**PROPOSED MORECAMBE OFFSHORE WINDFARM GENERATION ASSETS**

**REFERENCE: EN010121**

**RE: NATURAL RESOURCES WALES' WRITTEN SUBMISSION FOR DEADLINE 1**

**Figure 1** Location of Pen y Gogarth / Great Orme's Head SSSI

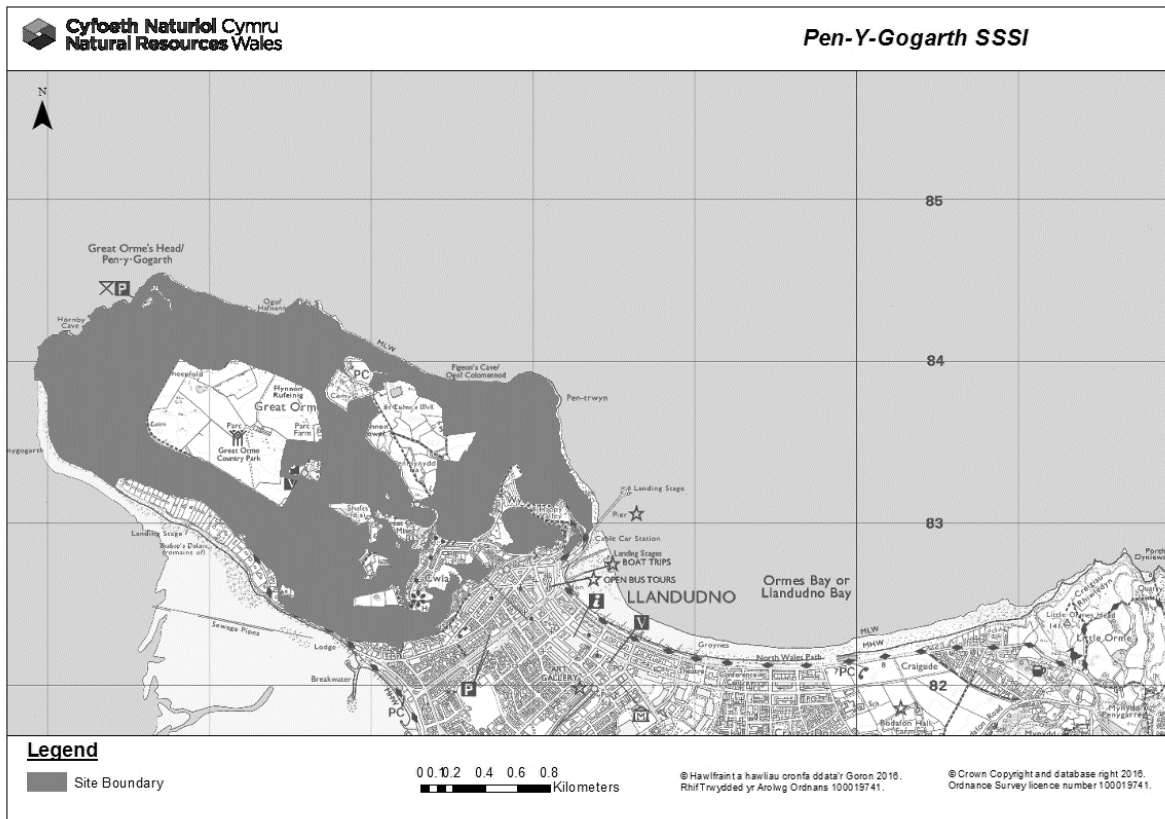
27. In our PEIR comments, NRW (A) highlighted that as the Morecambe Generation Assets project is located within foraging range of the guillemot, razorbill and kittiwake features of the Pen-y-Gogarth / Great Orme's Head SSSI, there was a need for the Applicant to present a full quantitative assessment of impacts from the proposed project on these features of the site. Whilst the Applicant presents a very high-level qualitative assessment of impacts to SSSIs in paragraphs 12.423-12.424 of Volume 5, Chapter 12 [APP-049], no quantitative assessment has been made in the submission of impacts to the guillemot, razorbill (both for displacement) or kittiwake (collision) features of this site. Therefore, the Applicant has not carried out assessment of potential impacts to this site sufficiently in order to enable the effects on the features of the site to be assessed.

28. The proposed location for the Morecambe Generation Assets array area is approximately 52km from Pen-y-Gogarth / Great Ormes Head Site SSSI (*Figure 1*). The cliffs host a large colony of breeding seabirds, and the site is designated for breeding kittiwake, guillemot and razorbill. This is the second largest kittiwake breeding colony in Wales and the largest in North Wales, supporting approximately 790 pairs (5-year mean of peak counts 2018-2022, excluding 2020 when no data were collected due to the COVID-19 pandemic). In addition, the site supports around 1,500 guillemots and 150 razorbills each year (figures also based on 5-year mean peak 2018-2022 excluding 2020).

29. NRW (A) advise that the Applicant should undertake full quantitative assessments of predicted impacts of displacement of the guillemot and razorbill and collision of the kittiwake features of the Pen-y-Gogarth / Great Orme's Head SSSI. We advise that displacement and collision risk impacts are apportioned to the site using the same approaches as used for the SPA/Ramsar assessment, i.e. to follow the NatureScot approach (as has already been done in Annex 2 of APP-070) for the breeding season and use the information in the respective Appendix A tables from Furness (2015) for the non-breeding seasons – as the SSSI colony will not be specifically listed in the Furness (2015) tables, we suggest that apportionment is informed by use of the adult proportion of birds for the 'western non SPA colonies' in the Furness 2015 Appendix A tables. We would be happy to discuss appropriate approaches further with the Applicant if required.
